Comment Status Summary	
Accepted:	1239
Rejected:	80
Cancelled / Withdrawn:	115
Unresolved:	127

Project T10/1711-D

Information technology - SCSI / ATA Translation (SAT)

Summary of Comments on SCSI / ATA Translation Standard

Figure 2 — ATA document structure

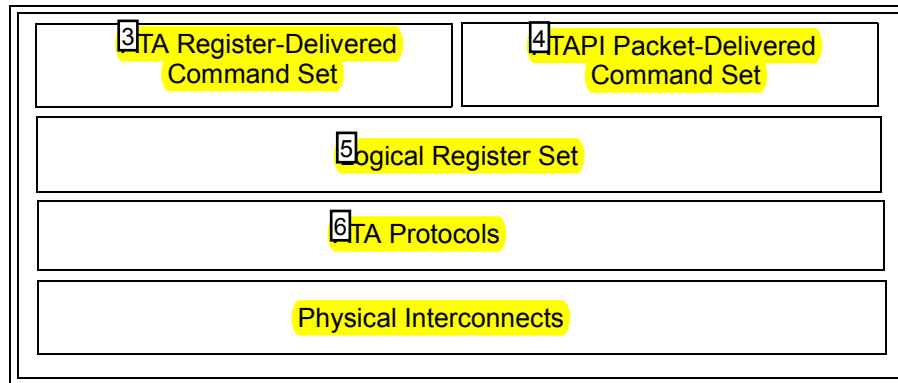
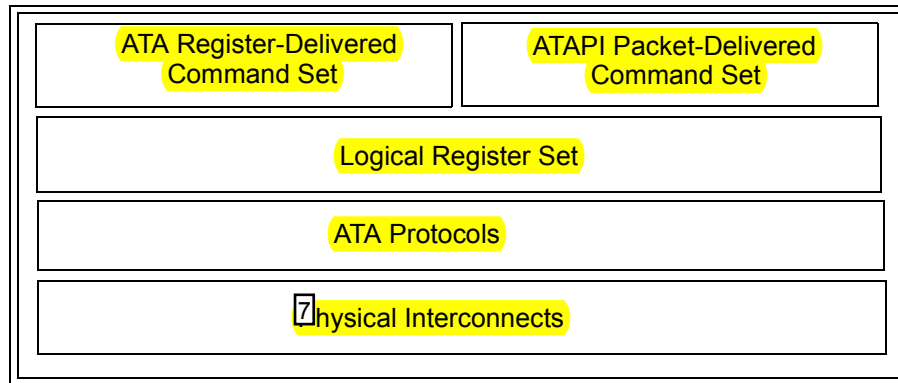
T In Figure 2

T In Figure 2

Figure 2

change
"ATA Protocols"
to
"ATA Transport Protocols"

T Figure 2
change
"Physical Interconnects"
to
"ATA physical interconnects"

RESOLUTION: Delete the box containing "Logical Register Set" as it doesn't appear in ATA/ATAPI-7.

Figure 3 — SCSI/ATA translation document role

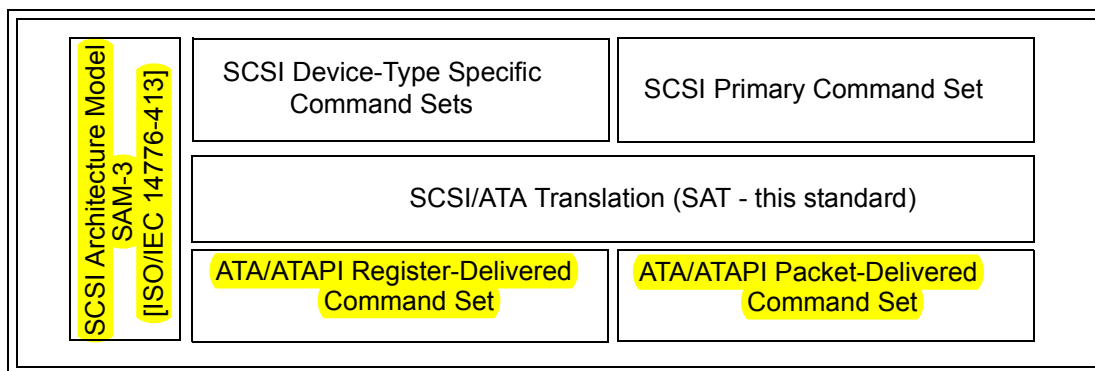
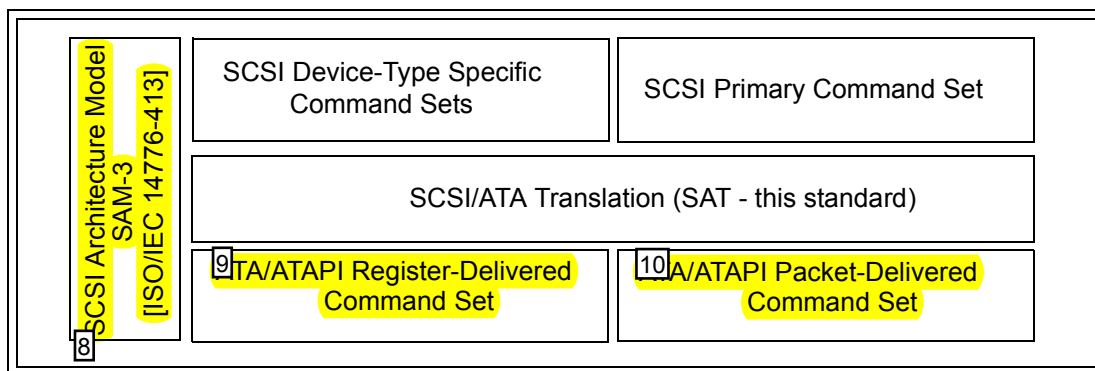
T In Figure 3, remove

T In Figure 3
change
"ATA/ATAPI Register-Delivered Command Set"
to
"ATA/ATAPI register delivered command set"

T In Figure 3
change
"ATA/ATAPI Packet-Delivered Command Set"
to
"ATA/ATAPI packet delivered command set"

Figure 4 — SAT functional protocol reference model

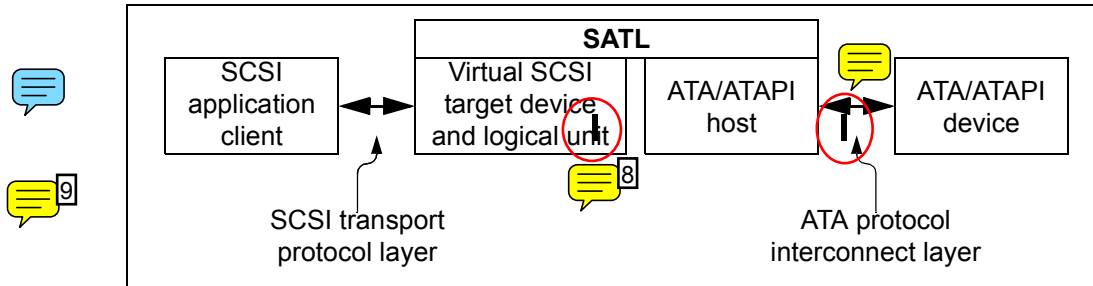
1. Remove what look like change bars in Figure 4
2. Change "logical unit" to "logical unit(s)"
3. Change "ATA protocol interconnect layer" to "ATA transport protocol interconnect layer"

Change the figure title to: "Figure 4 - Example of a SATL between a SCSI application client and an ATA/ATAPI device", fix change bars, and the change in item-3 as well.

Figure 5 — Identification descriptors included by a SATL in an ATA host

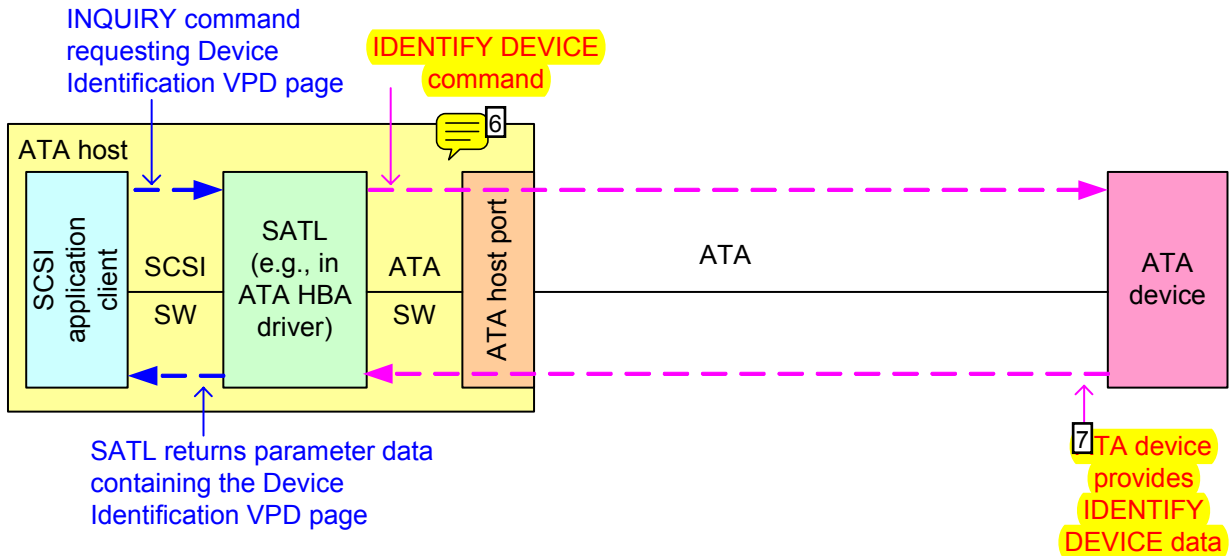
T In Figure 5 — Identification descriptors included by a SATL in an ATA host
change

T In Figure 5 — Identification descriptors included by a SATL in an ATA host
change

Figure 6 — Identification descriptors included by a SATL in a SAS initiator device

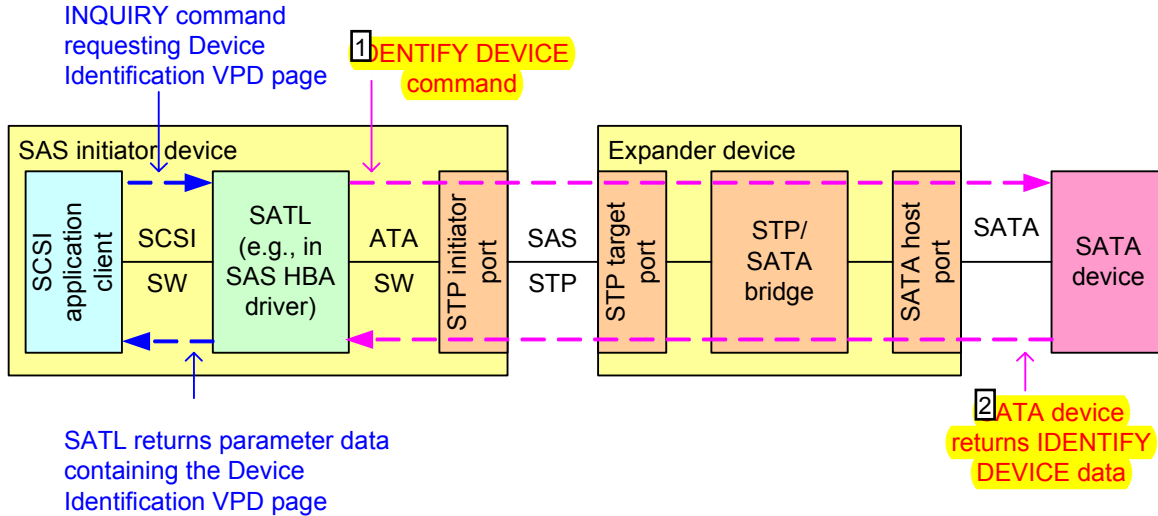
T In **Figure 6 — Identification descriptors included by a SATL in a SAS initiator device**

T In **Figure 6 — Identification descriptors included by a SATL in a SAS initiator device**

Figure 7 — Identification descriptors included by a SATL in a SCSI to ATA protocol bridge

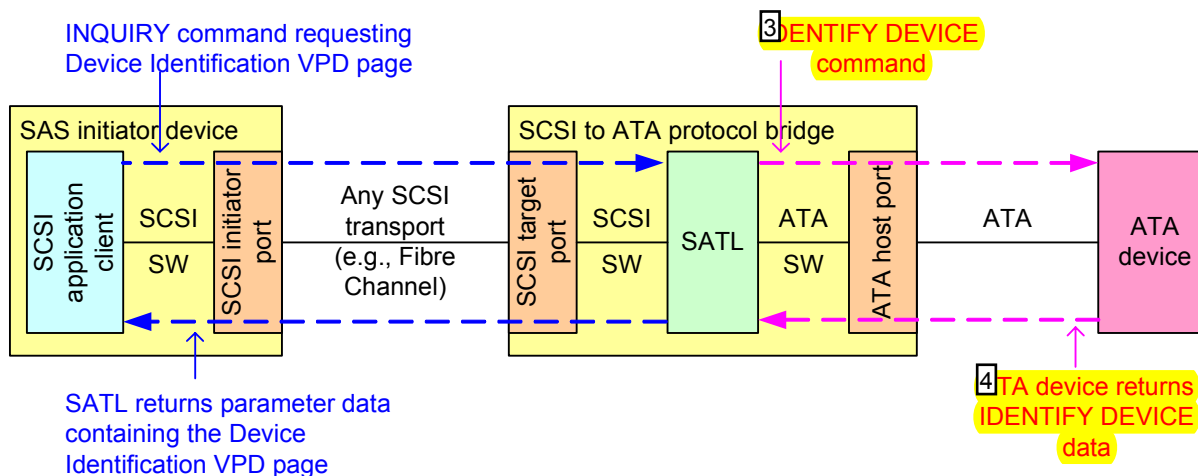
T In **Figure 7 — Identification descriptors included by a SATL in a SCSI to ATA protocol bridge**
change
"IDENTIFY DEVICE command"
to
"ATA IDENTIFY DEVICE command"

T In **Figure 7 — Identification descriptors included by a SATL in a SCSI to ATA protocol bridge**
change
"ATA device returns IDENTIFY DEVICE data"
to
"ATA device returns ATA IDENTIFY DEVICE data"
